ALKIMOS WASTEWATER TREATMENT PLANT AND OCEAN OUTFALL

EPA Assessment Number SITE A - 1582, SITE B - 1529

RESPONSE TO PUBLIC SUBMISSIONS ON PUBLIC ENVIRONMENTAL REVIEW

Figure 1. Vertical slice through diffuser discharge, orientated along shore, showing plume confined to surface layers

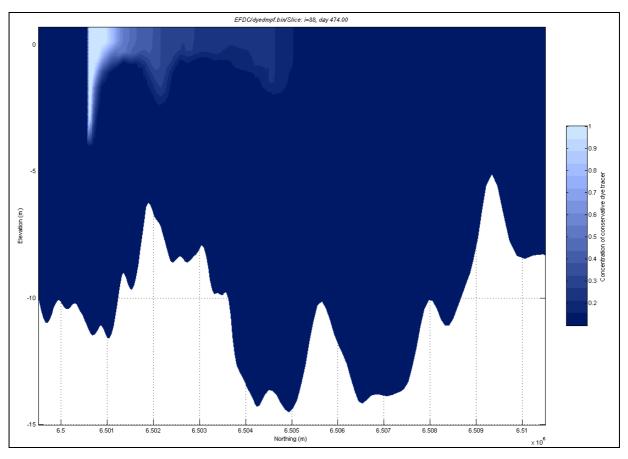
How has the farfield model been reconciled with the near field model (unspecified) for correct nitrogen concentration and mass flux from the discharge point?

The hydrodynamic modelling predicted the TWW plume would behave as expected for a buoyant plume. That is the modelled plume roses through the water column forming a relatively narrow vertical column above the discharge location and spreads out into a surface layer. The thickness of the surface layer depends on environmental conditions, particularly the degree of stratification and occurrence of wind-induced mixing events. The Oceanica water quality monitoring found that the waters offshore were not stratified.

Note that the TWW discharge was not introduced at the seabed. As the model used for this part of the work is a far-field model, the vertical discharge location was adjusted to match the modelled near-field dilution results at the water surface.

Under calm or low wind conditions, the fresh treated wastewater plume will rise to the surface (undergoing significant dilution as it rises) and then be dispersed in the surface waters. Under stronger wind conditions, the plume will be rapidly mixed in the water column and will not reach the water surface. The numerical modelling examined the potential for the plume to reach nearby reefs. The reason for the longer (3.5 km) outlet configuration being selected was to minimise the risk of the plume reaching the nearby reefs.

Figure 2. Wind speed record for the period 28 April to 28 May 2005, data supplied by Water Corporation from Station 100 at Alkimos

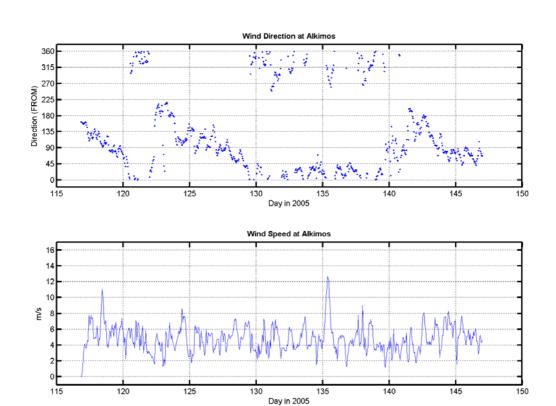
Validation of the model is only for late autumn/ early winter conditions – a validation for summer conditions is required.

The wind record from Alkimos for the current meter deployment was used for model calibration. The time series of wind speed and direction is provided in Figure 3 below. The record shows two periods of high winds, corresponding to storm events in late April and mid May. It also shows a few events typical of summer conditions, with easterlies and southerly and south-south westerly winds. As a whole, the results indicated the model was responding appropriately to different wind conditions and additional validation for summer conditions is not considered necessary.

Figure 3. Wind speed record for the period 28 April to 28 May 2005, data supplied by Water Corporation from Station 100 at Alkimos.

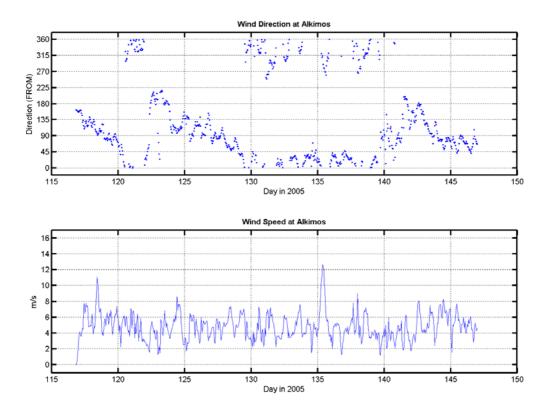
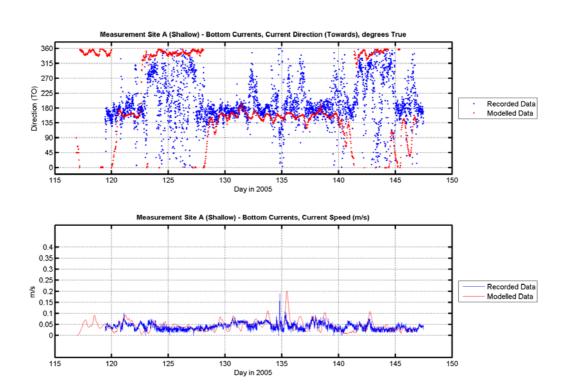
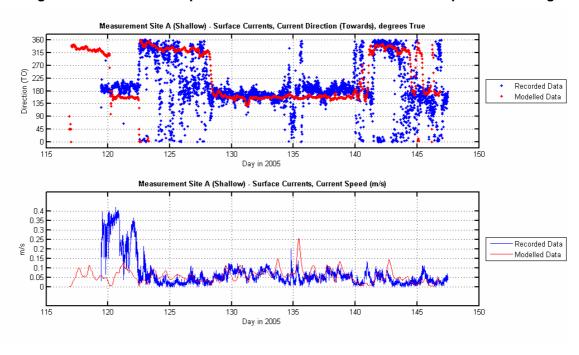
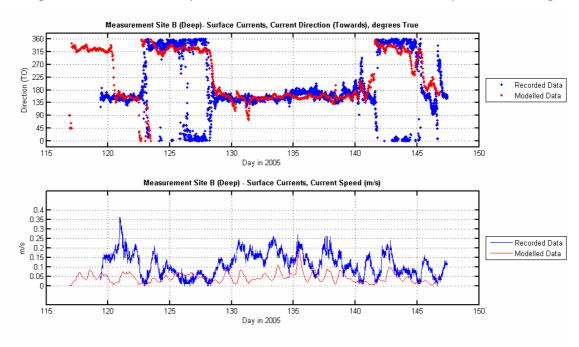
Exploration of the mean error, RMS error, scattergram plots and progressive vector plots are required to quantify the error between the measured and predicted model results (Submission 14).

An analysis of the mean error and RMS error was reported in WorleyParsons (2005) to quantify the error between the measured and predicted model results as reproduced below.

Note, in the following discussion wind directions are quoted as direction FROM and currents are shown as direction TO. That is, a northerly wind is expected to produce a southerly current.

Time series comparison plots of modelled and recorded near-bottom and nearsurface current speeds and directions are provided for both moorings (Figure 7 to Figure 7)

The time series plots of speed and direction generally show a good match between the modelled and recorded data, particularly at Mooring A within the reef environment. However, the greatest divergence between the modelled and recorded current speeds occurs at the beginning of the calibration period in the surface record at Mooring A.
